**CITY PLAN COMMISSION****THURSDAY, MARCH 2, 2023****FILE NUMBER:** S223-071**CHIEF PLANNER:** Mohammad H. Bordbar**LOCATION:** Botham Jean Boulevard, between Corinth Street and Parker Street**DATE FILED:** February 3, 2023**ZONING:** PD 317 (Subdistrict 3)**PD LINK:** <https://dallascityhall.com/departments/city-attorney/Articles/PDF/Article%20317.pdf>**CITY COUNCIL DISTRICT:** 2 **SIZE OF REQUEST:** 2.528-acre**MAPSCO:** 45V**APPLICANT/OWNER:** Popeyes Texas Partners, LLC

**REQUEST:** An application to replat a 2.528-acre tract of land containing all of Lots 1, 2, 6, and 3A in City Block G/889 to create one lot on property located on Botham Jean Boulevard, between Corinth Street and Parker Street.

**LARKSPUR CORINTH AD**  
**LOT 7AR, BLOCK G/889**

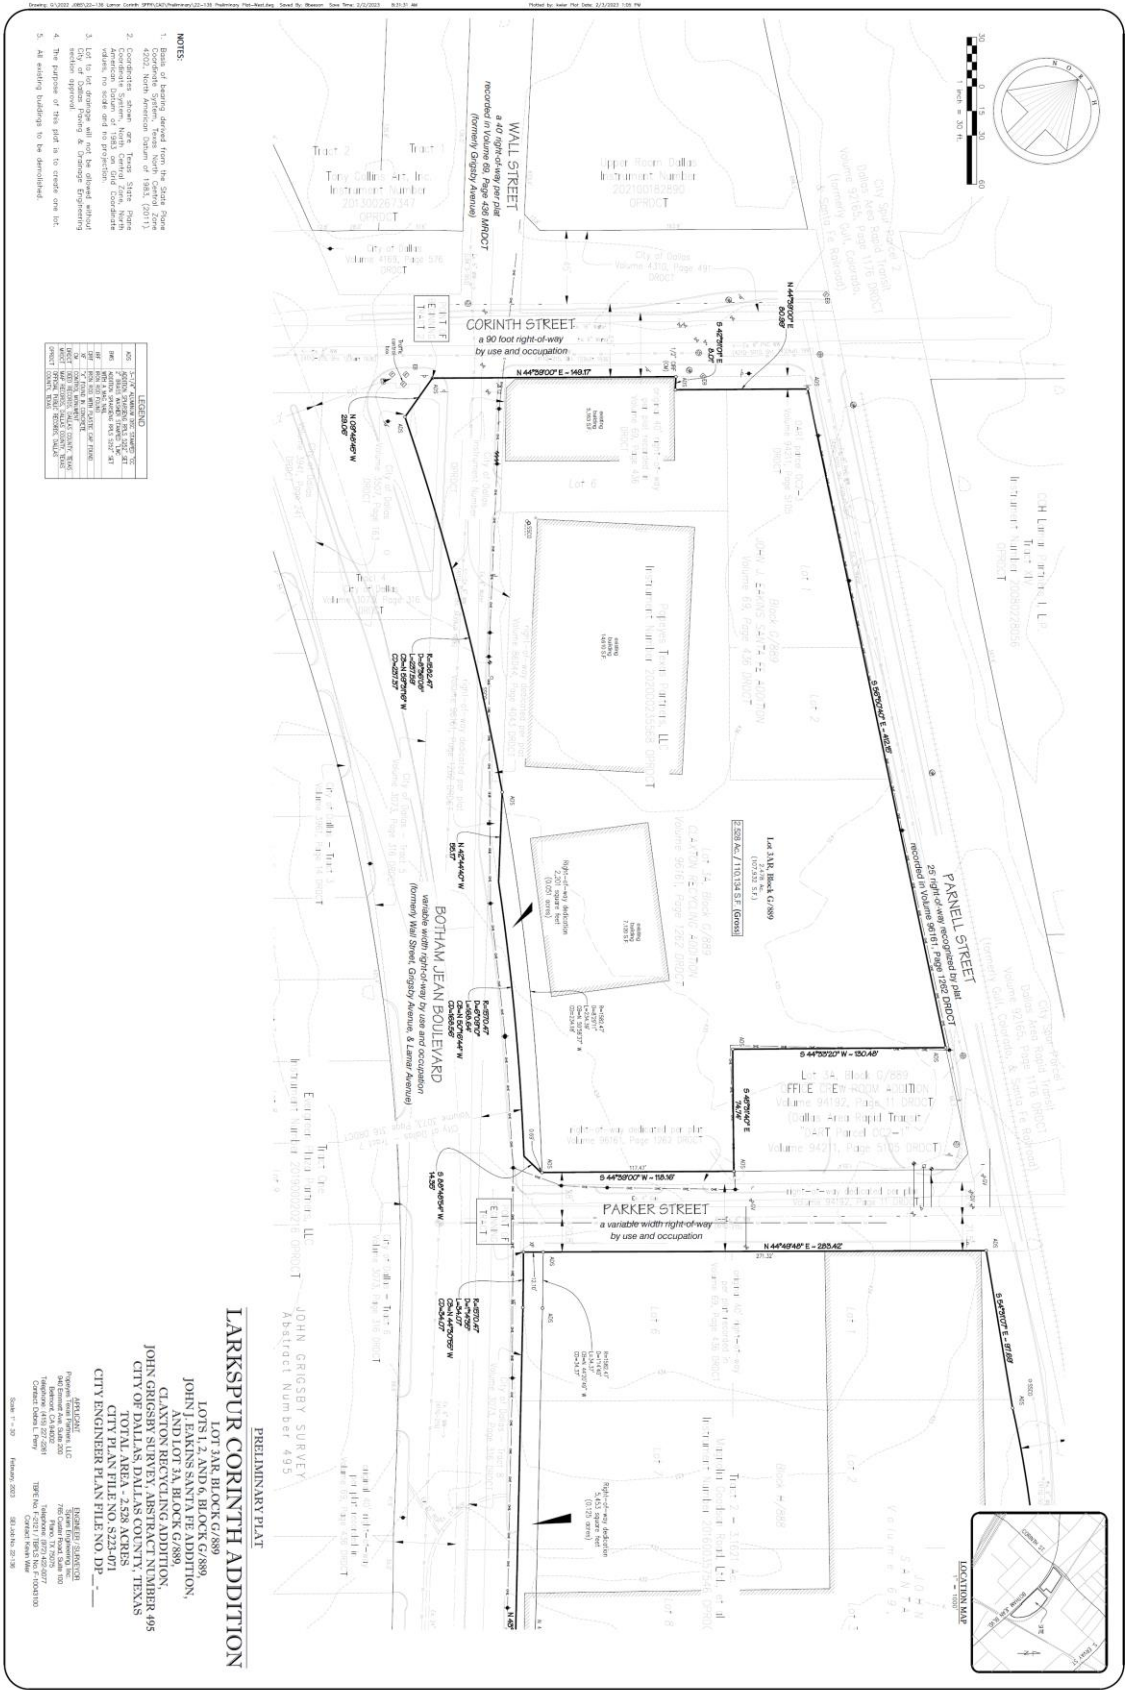
15. On the final plat, dedicate 50' of right-of-way (via fee simple) from the established center line of Botham Jean Boulevard *Section 51A 8.602(c)*
16. On the final plat, dedicate 25' feet of right-of-way (via fee simple or street easement) from the established centerline of Parnell Street *Sections 51A-8.602(c), 51A-8.604(c) and 51A-8.611(c)*.

17. On the final plat, dedicate a minimum 25 feet x 25 feet corner clip (via fee simple or street easement) at the intersection of Botham Jean Boulevard & Corinth Street *Section 51A 8.602(d)(1)*

18. On the final plat, dedicate a 10 feet x 10 feet corner clip (via fee simple or street easement) at the intersection of Corinth Street & Parnell Street respectively *Section 51A 8.602(d)(1)*

21. Prior to final plat, clarify extension of Wall St. within the plat as either abandonment or dedicate 50' ROW.

22. Prior to final plat, submit a completed final plat checklist and all supporting documents.
23. On the final plat, show distances/width across all adjoining right-of-way. Platting Guidelines.

27. Prior of final plat, contact Real Estate to discuss building encroaching into the right-of-way of Corinth Street.
28. On the final plat, change “Botham Jean Boulevard Formerly Wall Street, Grigsby Avenue & Lamar” to “Botham Jean Boulevard (F.K.A. Lamar Street) (F.K.A. Wall Street) (F.K.A. Grigsby Avenue” 51A-8.403(a)(1)(A)(xii)
29. On the final plat, identify the property as Lot 1A in City Block G/889. Ordinance 1A, Page 131 pages 131-148, Section 2 (passed August 13, 1872).
